DECLARATION FOR THE RECORD OF DECISION

Carroll and Dubies Superfund Site
Town of Deerpark, Orange County, New York

SAMPLE LOCATION MAP

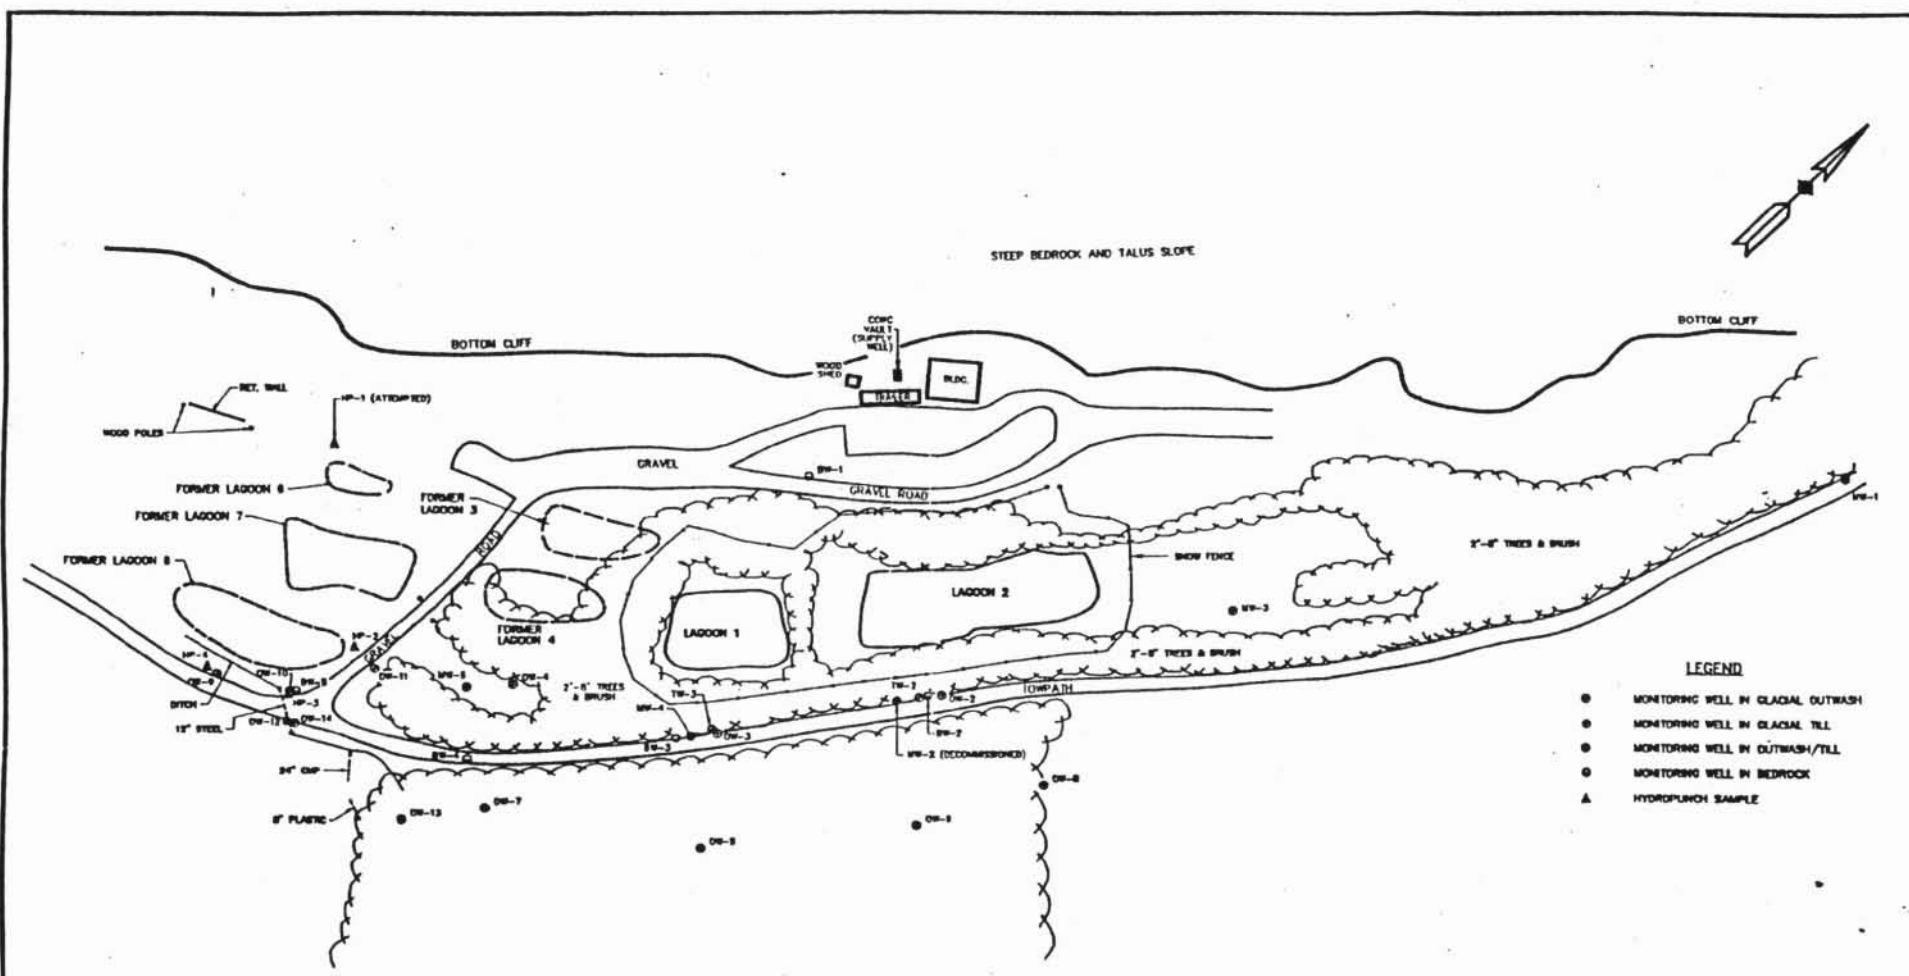
1. **COMMENT:** A resident requested that the existing results of the groundwater sampling conducted at the site be summarized. The resident was also interested in the location and depth of the monitoring wells, as well as any plans to install monitoring wells further downgradient of the existing monitoring wells.

EPA RESPONSE: It should be noted that the groundwater contamination will be addressed in operable unit II, as such the groundwater investigation is not yet complete. A significant amount of data have already been generated from the on-going investigation. During 1991 and 1993, groundwater samples were collected from monitoring wells located within approximately 150 feet of the lagoons at the site and were analyzed for organic and inorganic compounds. (Refer to Figure 3 contained in the Record of Decision (ROD) for the location of the monitoring wells.) Results can best be described relative to lagoons 1 through 4 and 6 through 8. (Lagoon 5 is not considered here since it contained tires and not industrial wastes.) Results indicated that organic compounds (benzene, 1,2-dichloroethene, tetrachloroethene and trichloroethene) were detected above drinking water standards in the groundwater samples collected from the monitoring wells located nearest to lagoons 1 through 4 (e.g., MW-4, OW-2, OW-3), but were detected at or near the State or Federal drinking water standards in the groundwater samples collected from the wells located furthest from lagoons 1 through 4 (e.g., OW-5, OW-6, OW-7 and OW-8). During the 1993 sampling event, inorganic compounds were detected at or near the drinking water standards. Based on the results of this sampling, the horizontal extent of the groundwater contamination plume was determined to extend no farther than approximately 150 feet downgradient of lagoons 1 through 4.

furthest downgradient monitoring wells, it is evident that a plume extends beyond the existing monitoring wells. In August and September of 1994, additional monitoring wells were installed (not shown in Figure 3) and groundwater samples were collected to determine the extent of the groundwater contamination plume. These monitoring wells extended as far as the downgradient edge of the City of Port Jervis landfill (approximately 1,000 feet from the site). Additional monitoring wells will be installed if the results of the recent sampling indicate that the site groundwater contamination plume extends beyond the downgradient edge of the landfill. A RI report which summarizes the groundwater sampling data from the site is expected to be completed in mid 1995, while a Proposed Plan which addresses the groundwater at the site is expected to be completed shortly thereafter.
